MANDATORY**SEL-57-05****TITLE**

WINGS - BONANZA STALL STRIP RELOCATION

Bonanza G36

E-4110 thru E-4112

Figure 1. Bonanza Stall Strip Relocation (Sheet 1)

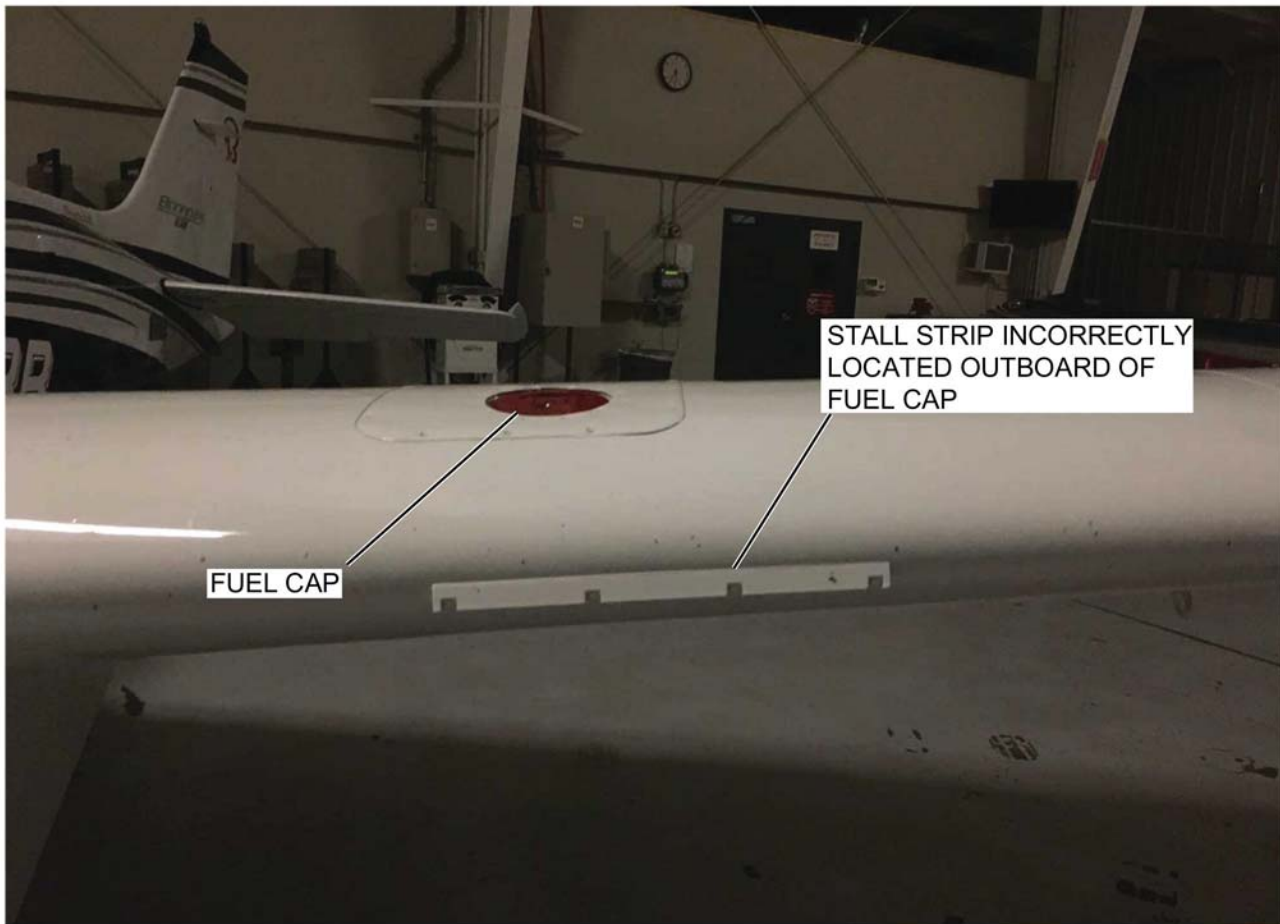
1. (Refer to Figure 1, Sheet 1 and Sheet 2.) Inspect to determine if the left hand stall strip is installed outboard of the fuel cap.
 - A. If the stall strip is outboard of the fuel cap, it must be relocated. Go to Step 2.

- B. If the stall strip is correctly installed inboard of the fuel cap, no further action is required. Go to Step 6.
2. Prepare the airplane for maintenance.

Figure 1. Bonanza Stall Strip Relocation (Sheet 3)

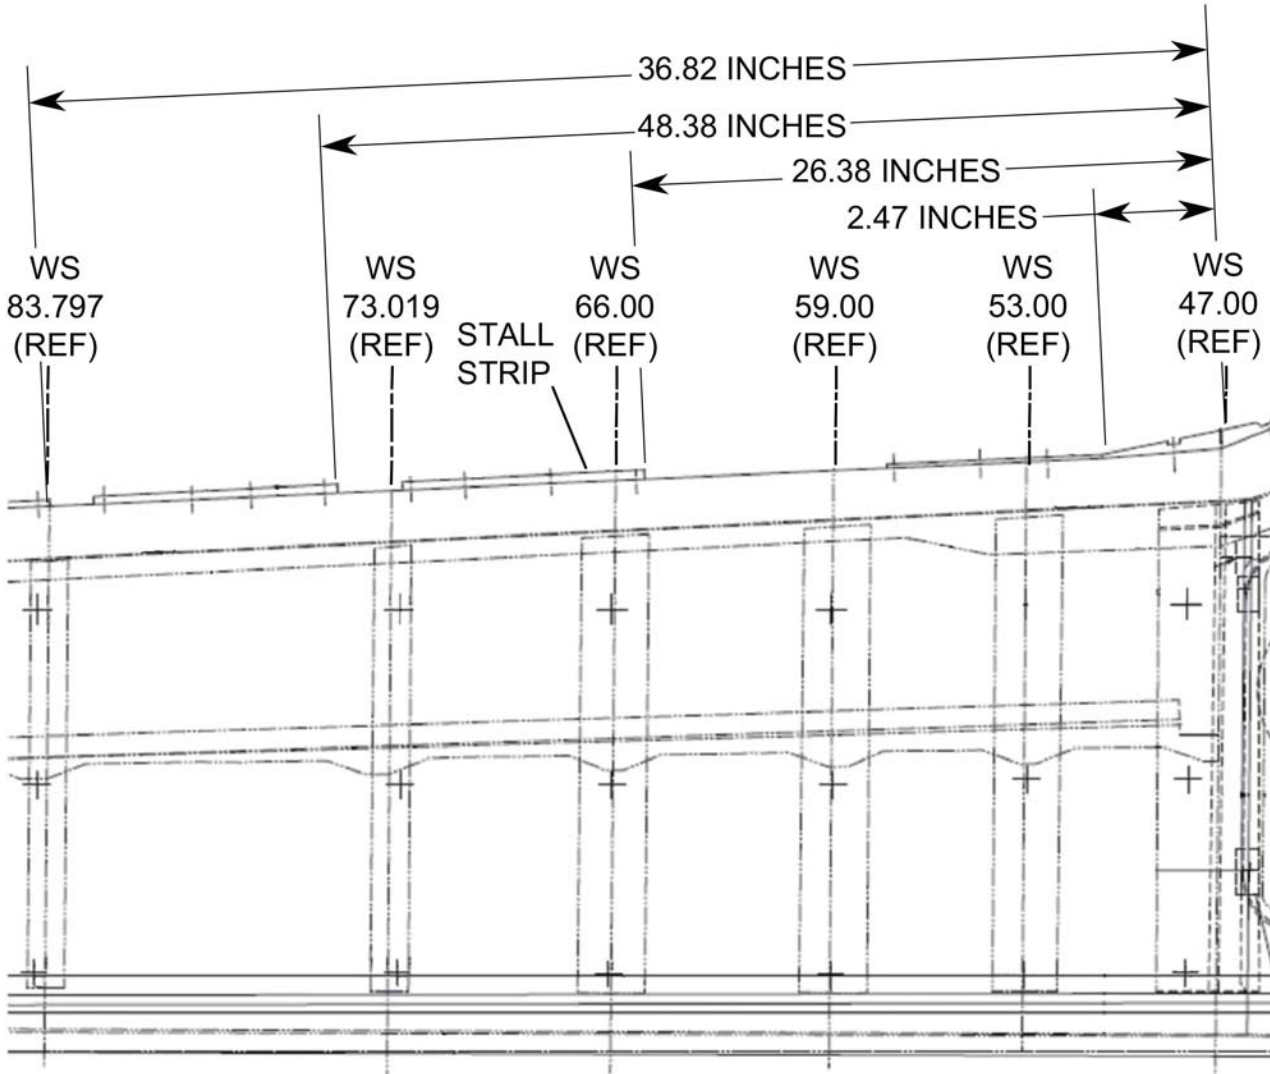
3. (Refer to Figure 1, Sheet 3.) Relocate the stall strip:
 - A. Remove rivets from existing stall strip.
 - B. Remove the stall strip.
 - C. Remove rivet butts/FOD from the leading edge.

- D. Discard rivets.
 - E. Plug open rivet holes at the location from which the stall strip was removed:
 - (1) Drill the existing four rivet holes in the wing skin to 9/64-inch diameter.

- (2) Countersink 100° x 0.165-inch diameter.

- (3) Protect all exposed bare material with Alodine and Epoxy primer.
- (4) Install four new CR3245-4-1 Rivets in the open, countersunk holes.
- F. (Refer to Figure 1, Sheet 3.) Position one end of the removed stall strip 26.38 inches outboard of wing station 47.00, with the opposite end of the stall strip extending outboard.

- H. (Refer to Figure 1, Sheet 3.) Hold the stall strip at the defined position and match/drill four 0.128-inch diameter rivet holes from the stall strip to the wing skin.

Figure 1. Bonanza Stall Strip Relocation (Sheet 4)

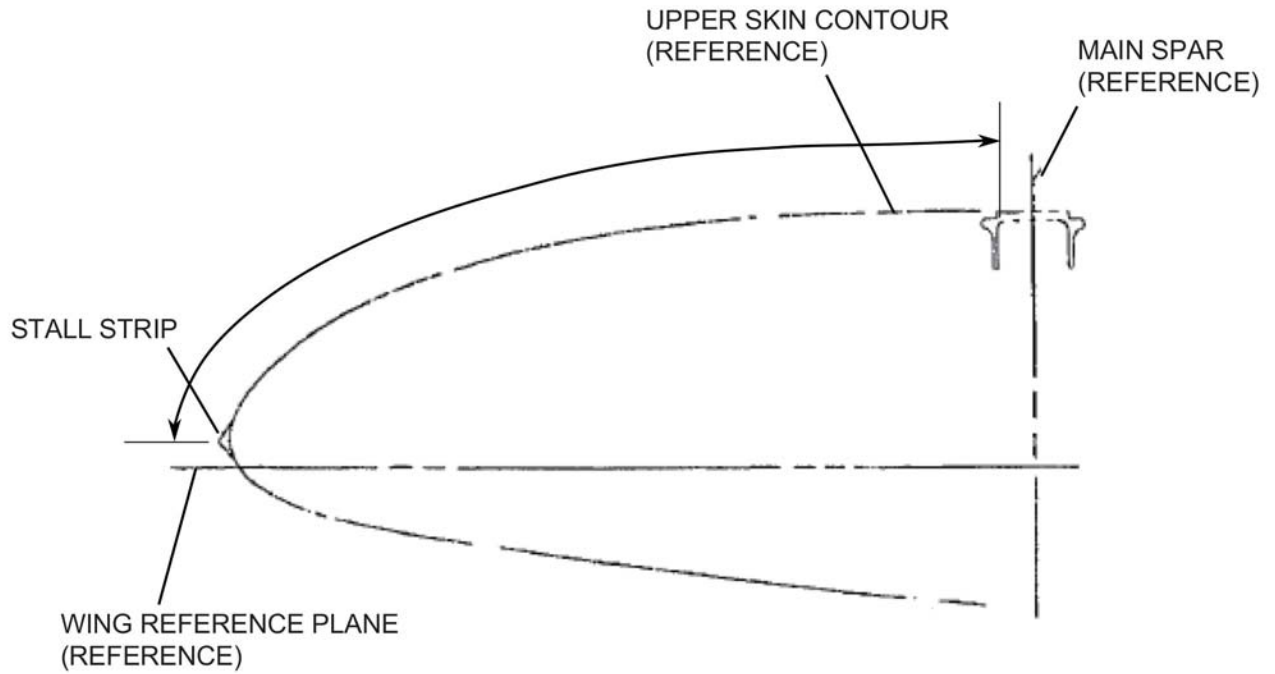
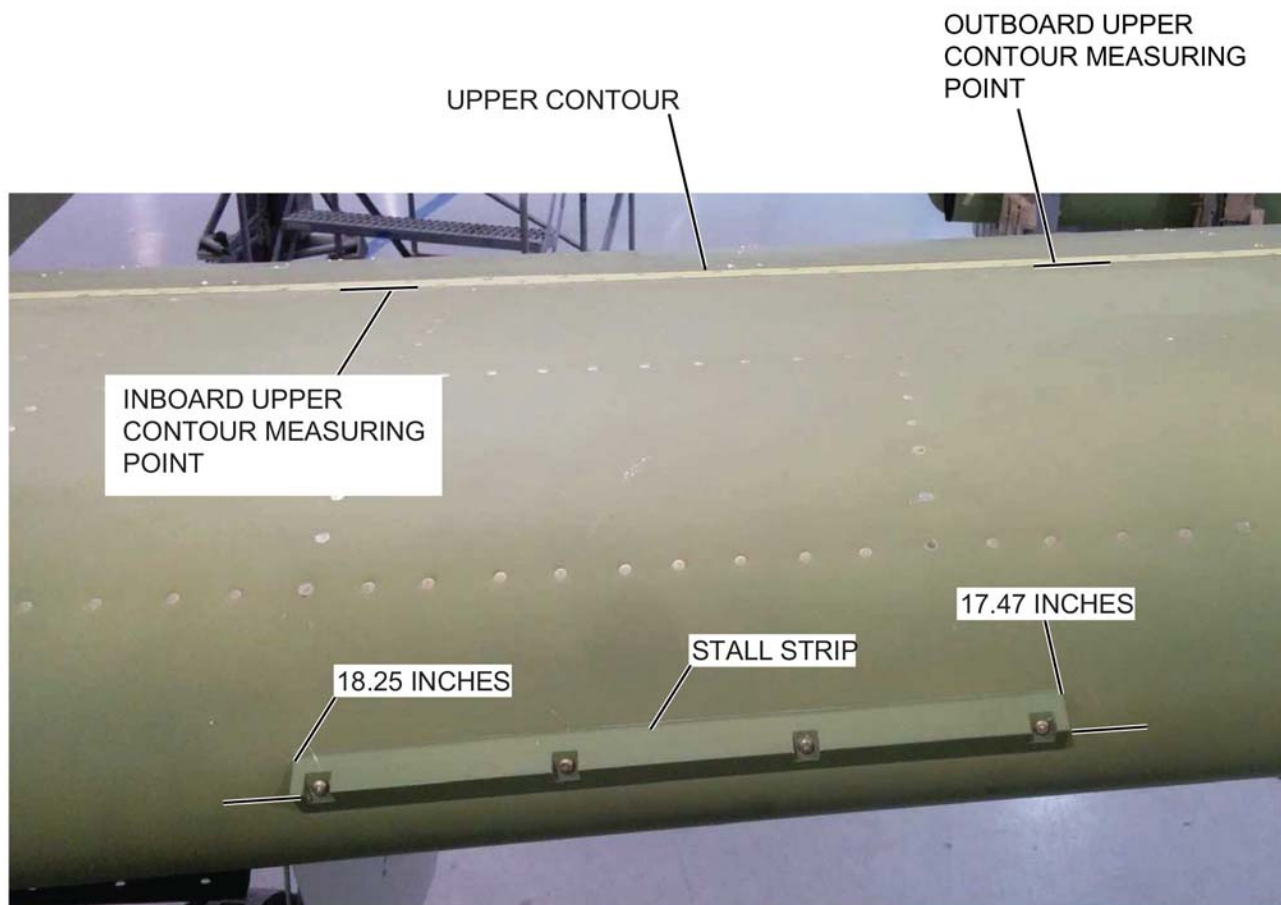
- G. (Refer to Figure 1, Sheets 4 and 5.) Position the apex of the outboard edge of the stall strip 17.47-Inches from the forward edge of the wing spar measured along the upper contour. Position the apex of the inboard edge of the stall strip 18.25-Inches from the forward edge of the wing spar measured along the upper contour.
